BAR Meeting
March 5, 2014

ISSUE: Demolition and New Construction

APPLICANT: Carr Hospitality by Rust Orling Architecture

LOCATION: 220 South Union Street

Figure 3. Courtyard elevation showing 2a area suggestion for revision. Dashed line indicates the potential continuation of pitched roof with lighter building 2 color.

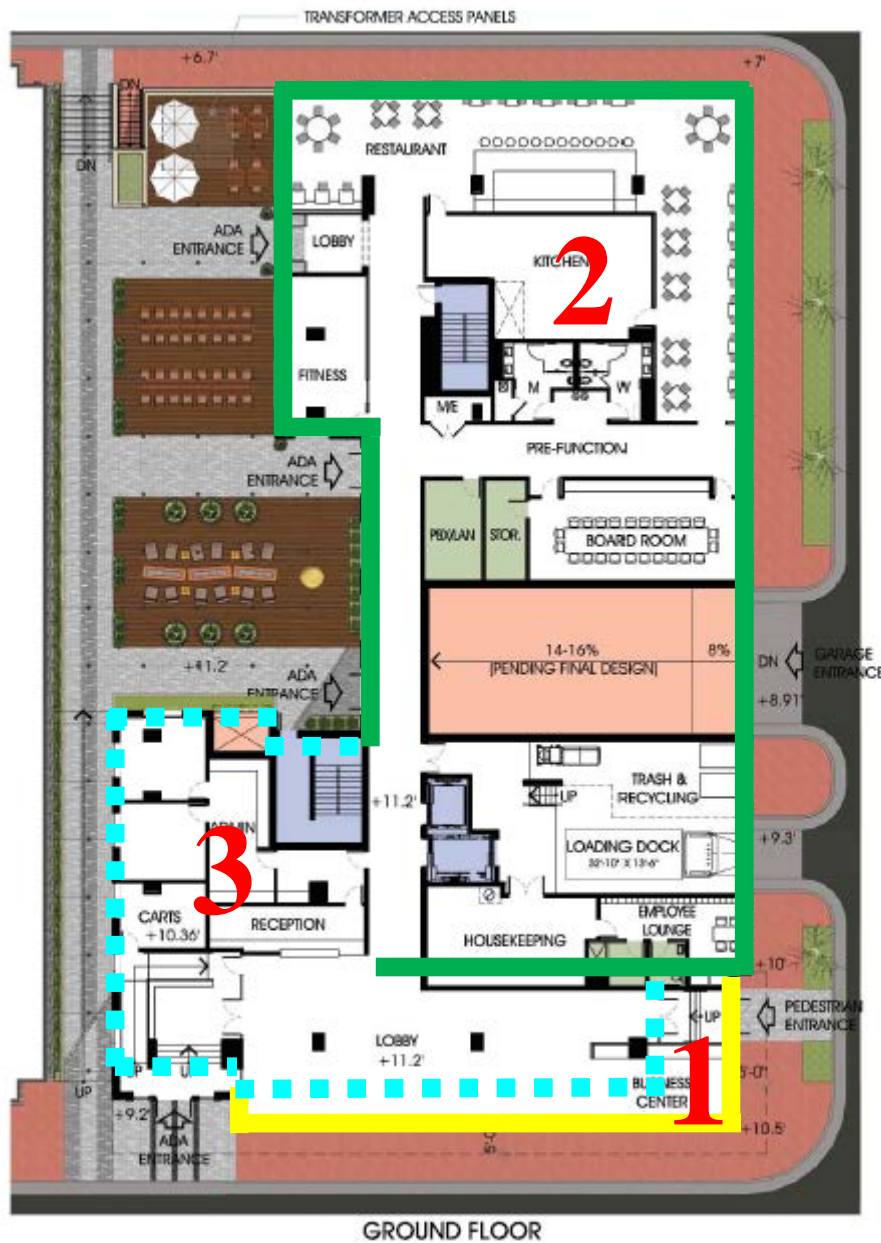
1. That the project read as three distinct but compatible building masses and that the materials, colors and details be standardized for each building. This includes a uniform color scheme, fenestration and architectural details for each “building”; the addition of the gable form on The Strand carried through to the western terminus of that building mass; as well as refinement of the courtyard elevation shown as “2a” in Figure 3.

The courtyard elevations presently show the very dark red brick (B2) color facing north between two tan colored (B1) building masses. The courtyard elevations would have to be restudied to determine where the buff should end and the salmon should begin under the three building scheme.
